DEPARTMENT OF THE ARMY
OFFICE OF THE ASSISTANT CHIEF OF STAFF FOR INSTALLATION MANAGEMENT
600 ARMY PENTAGON
WASHINGTON, DC 20310-0600

RE: Final RCRA Facility Investigation Phase 2 Work Plan, Parcel 11 Army's Response to Comments, Disapproval Letter Dated December 6, 2016 HWB-FWDA-15-018, Fort Wingate Depot Activity, McKinley County, New Mexico.

NMED Comment 4: Figure 4-1, Phase 2 Sample Locations SWMU 6 - Former Building 11 and AOC 47 TPL Spill and Photoflash Powder

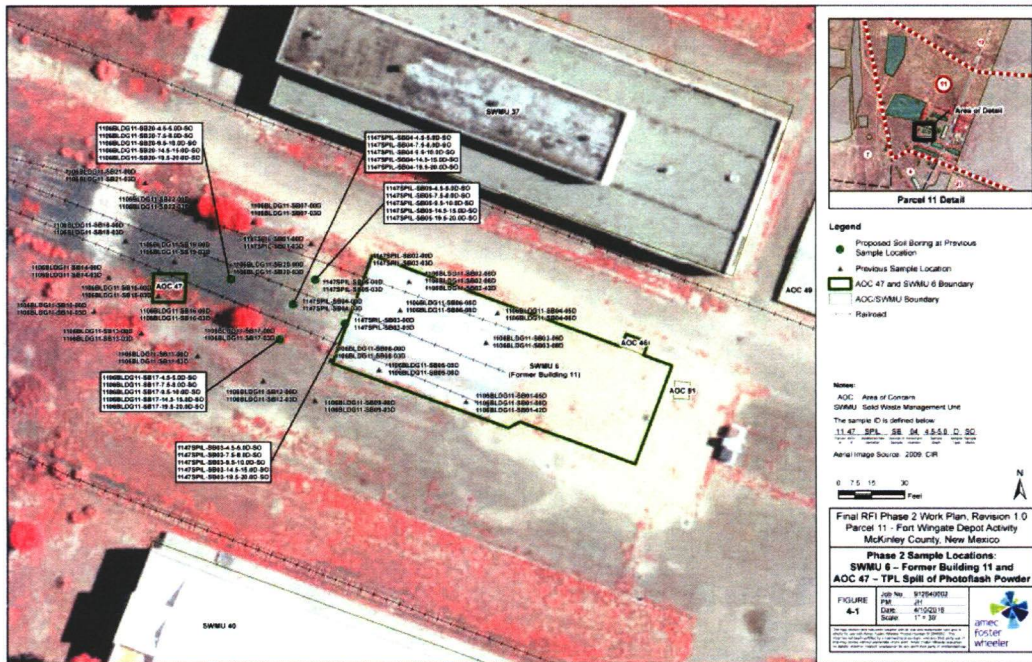
NMED's Comment:

The figure is confusing because there are multiple wells with the same designations. SB-01 through SB-05 are each presented at two different locations. Revise the figure to distinguish the soil borings from one another. In addition, for future soil borings, refrain from naming nearby soil borings or wells with similar designations in order to avoid confusion.

Army Response:

The soil boring designations on Figure 4-1 have been expanded in order to distinguish one from the other. Revised Figure 4-1:

NMED Comment 6: Figure 6-1, Phase 2 Sample Locations SWMU 23 Building 7 and Building 8

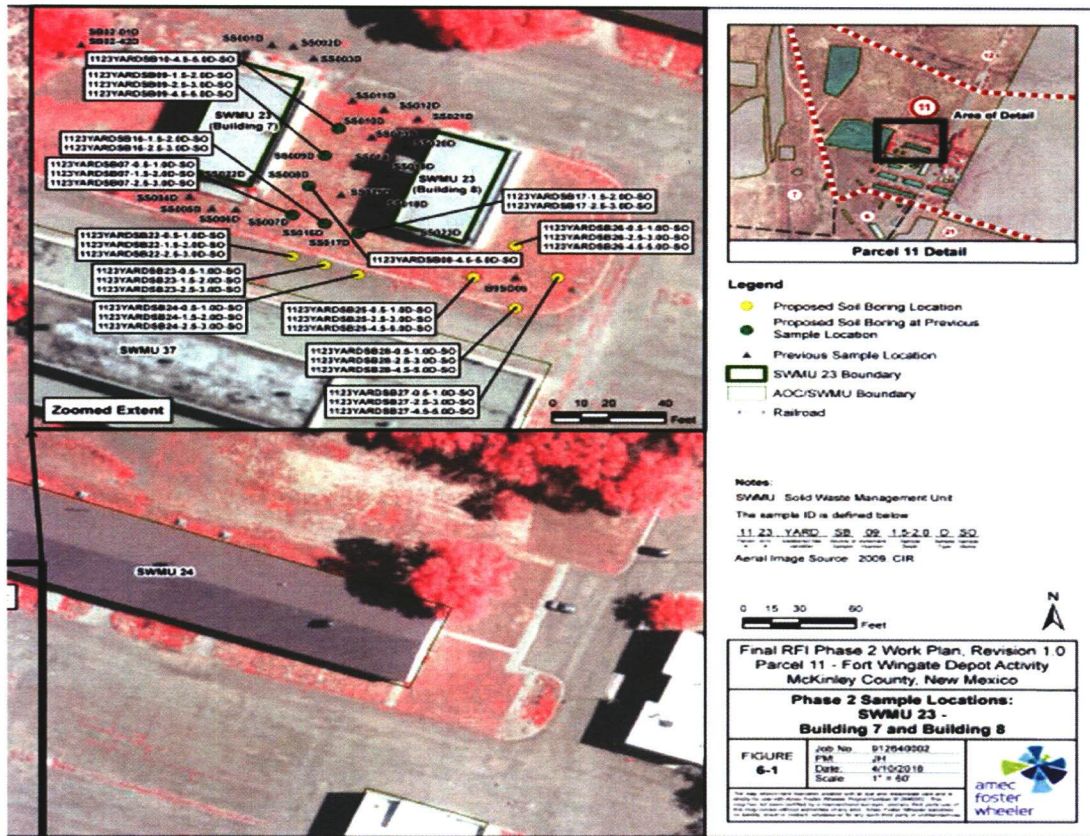
NMED's Comment:

The inset map on this figure does not contain a scale. A scale must be provided for inset maps on this and all other figures with insets for all work plans and reports. Revise the figure accordingly.

Army Response:

A scale has been added to the Figure 6-1 inset map.
